METROPOLITAN GOVERNMENT OF NASHVILLE AND DAVIDSON COUNTY

STAFF RECOMMENDATION
2020 10th Avenue South
October 16, 2019

Application: New Construction—Outbuilding (Detached Accessory Dwelling Unit)
District: Waverly-Belmont Neighborhood Conservation Zoning Overlay
Council District: 17
Map and Parcel Number: 10509041200
Applicant: William Smallman
Project Lead: Melissa Sajid, melissa.sajid@nashville.gov

Figure 1. 2020 10th Avenue South

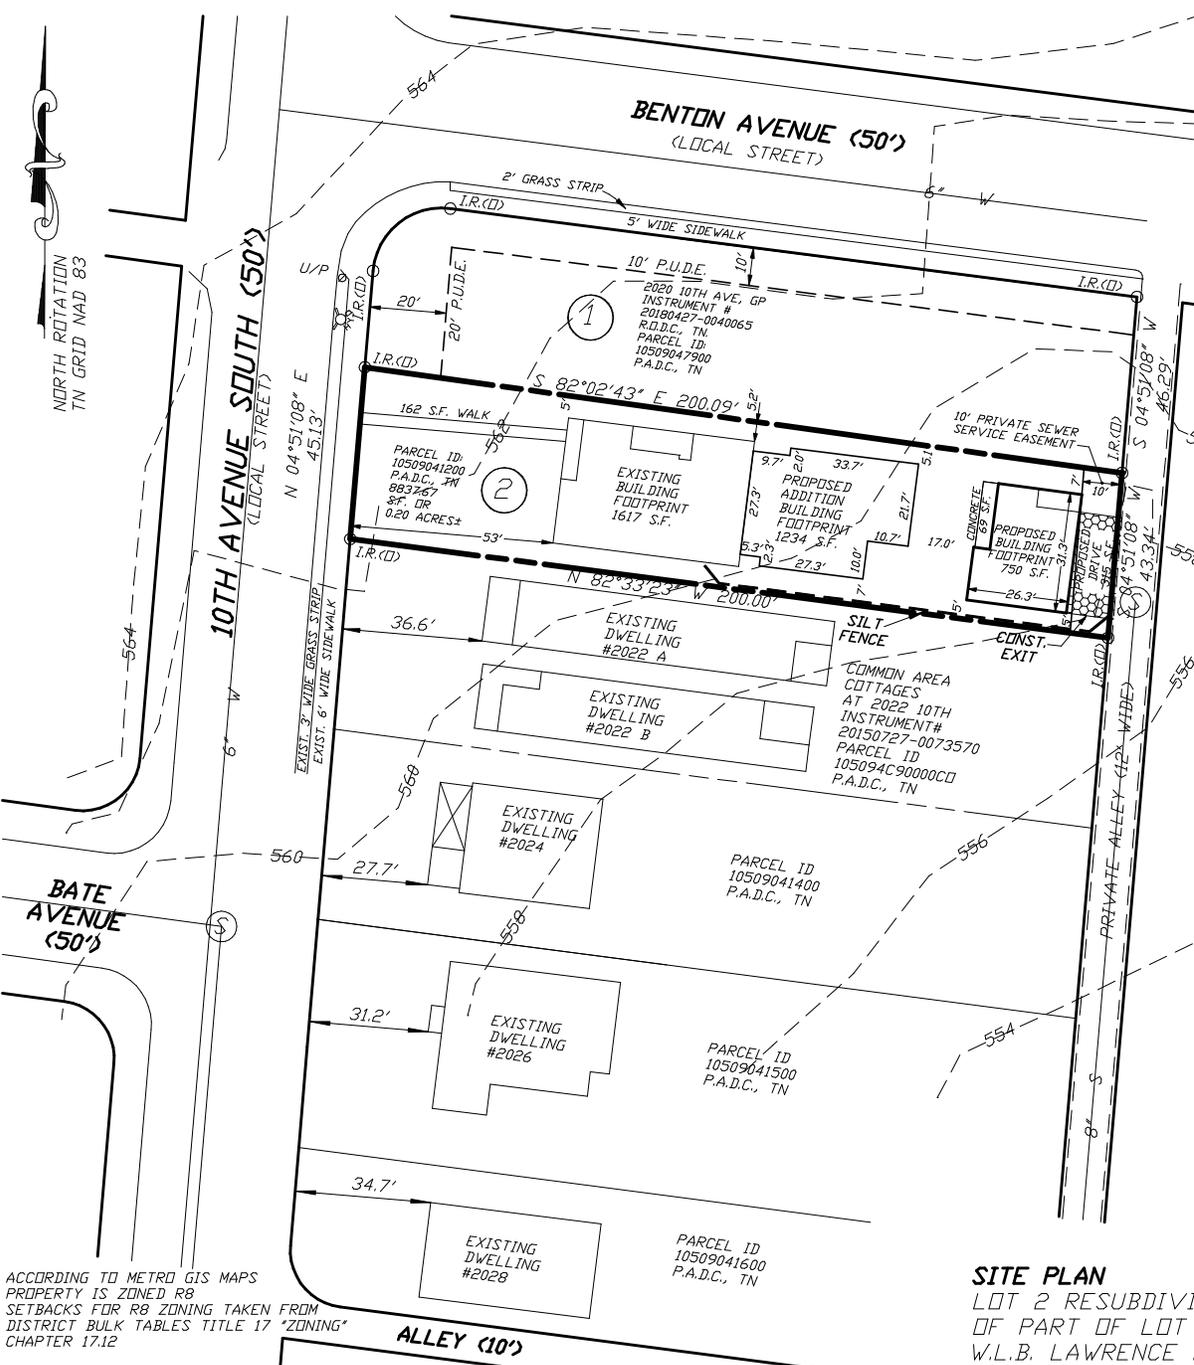
Background: The house located at 2020 10th Avenue South was likely built c. 1880, which makes it one of the oldest houses in the Waverly-Belmont neighborhood (Figure 1). As such, the house contributes to the historic character of the neighborhood. The Commission approved an addition and alterations to the historic house in June 2019.

SITE PLAN

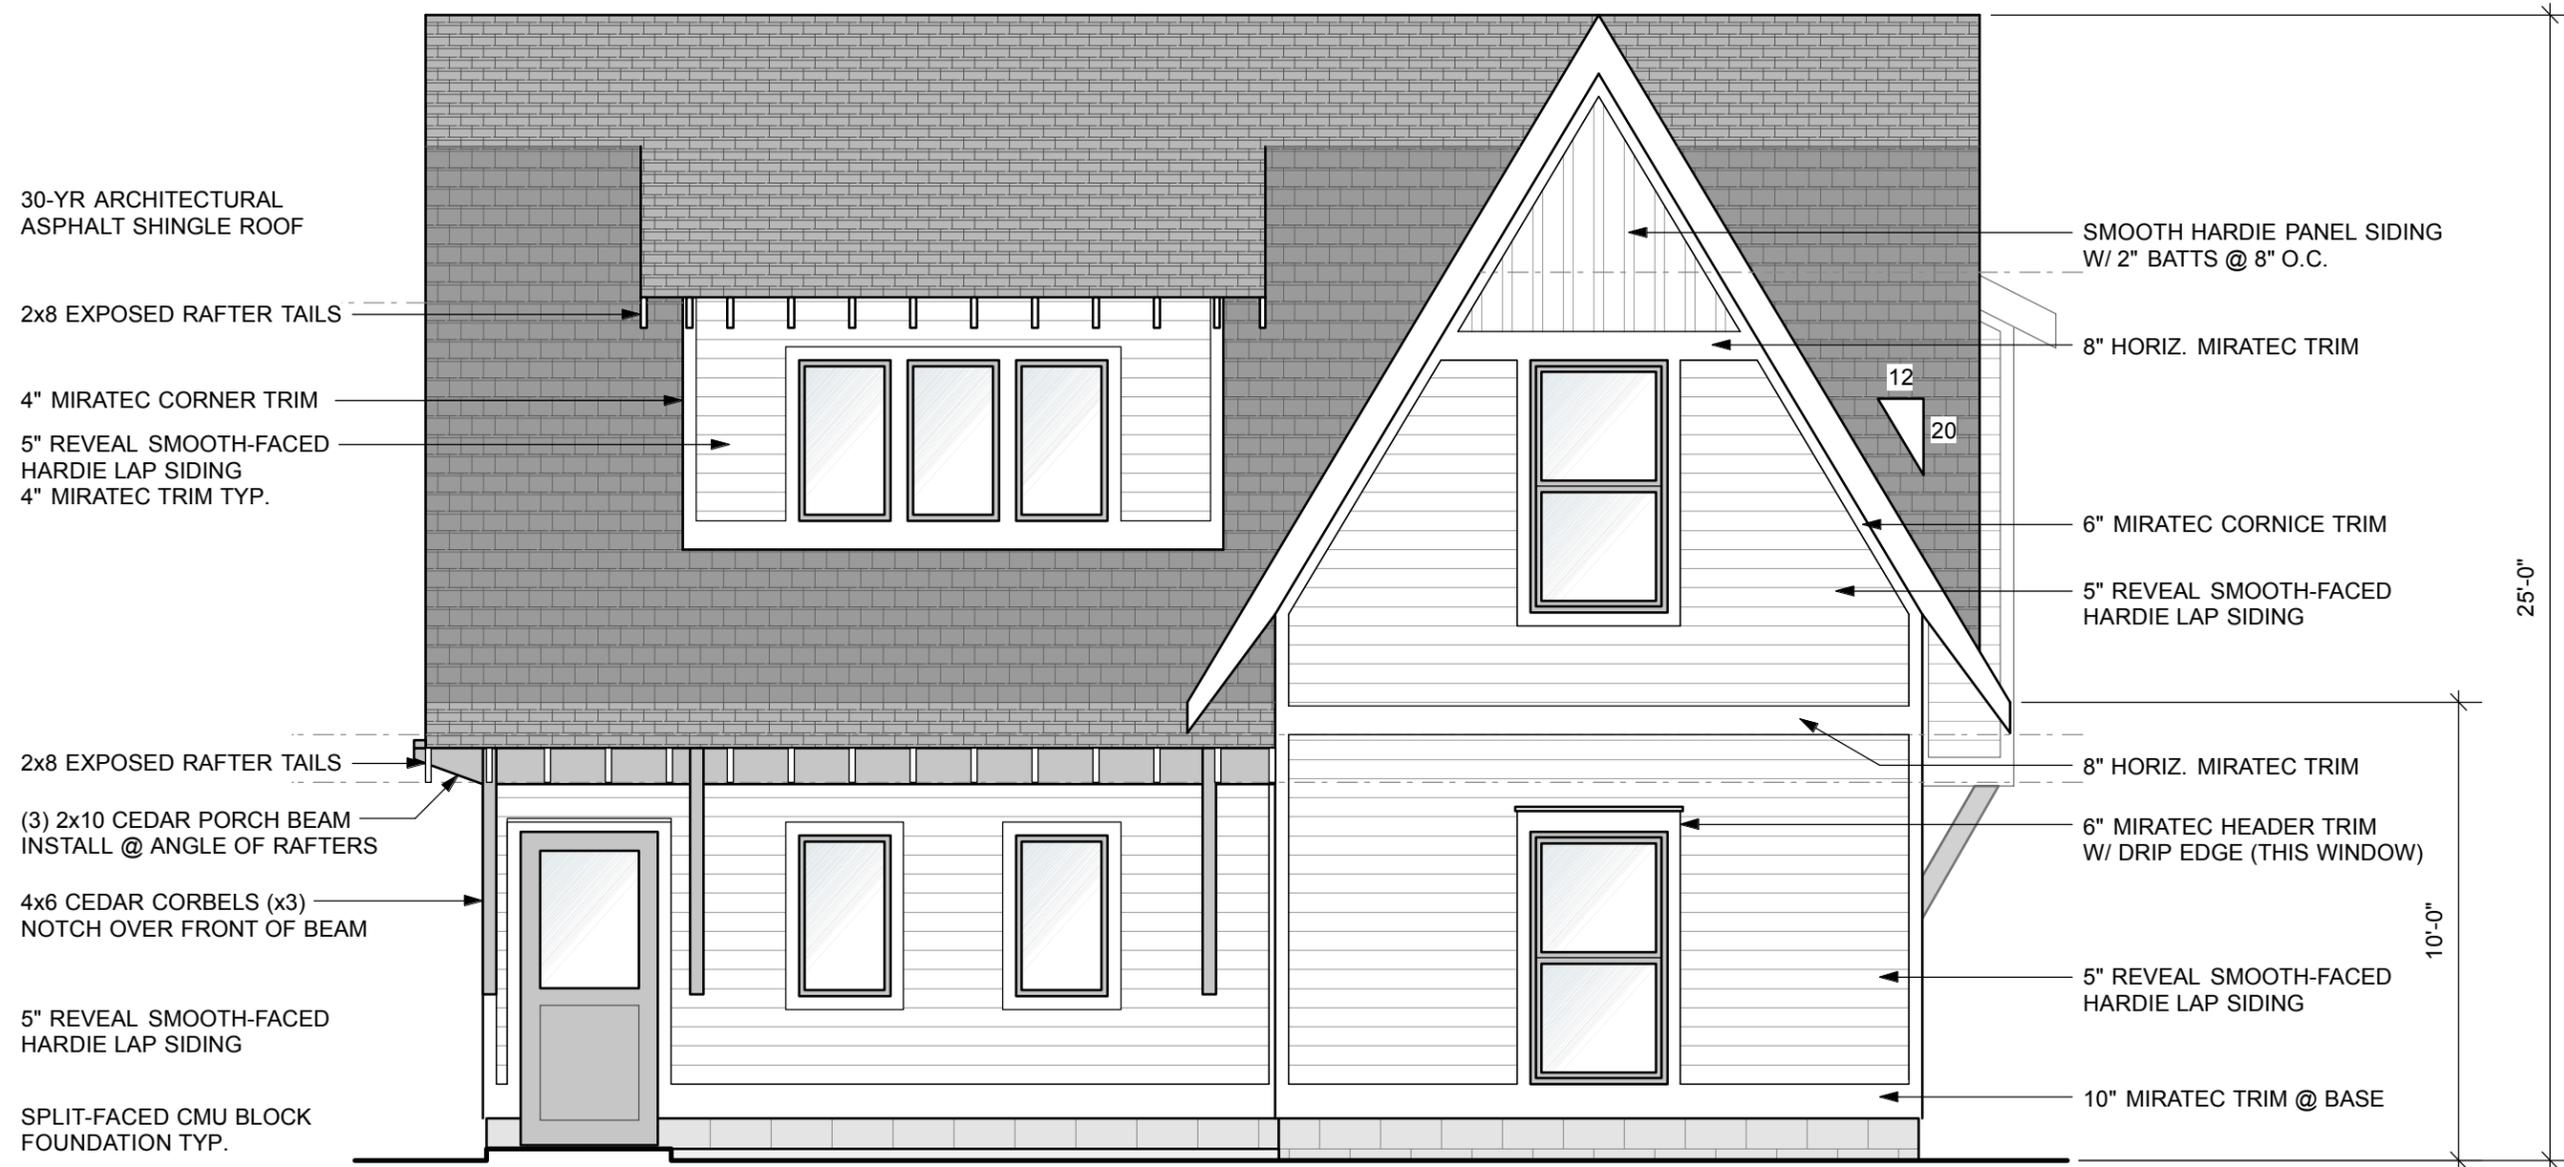
MINIMUM	PROPOSED
Building located towards rear of lot	-	Yes
Space between principal building and garage	20’	17’’
Rear setback	5’	10’
Left side setback	5’	7’
Right side setback	5’	5’
How is the building accessed?	-	From alley
Two different doors rather than one large door (if street facing)?	-	N/A

The outbuilding is located at the rear of the lot and will be accessed via the alley. As proposed the outbuilding meets all base zoning setbacks but is located less than twenty feet (20’) from the rear of the proposed addition.

Staff finds that the application does not meet Section III.H.6.d of the design guidelines and Section 17.16.030.G.4 of the DADU Ordinance for setbacks.
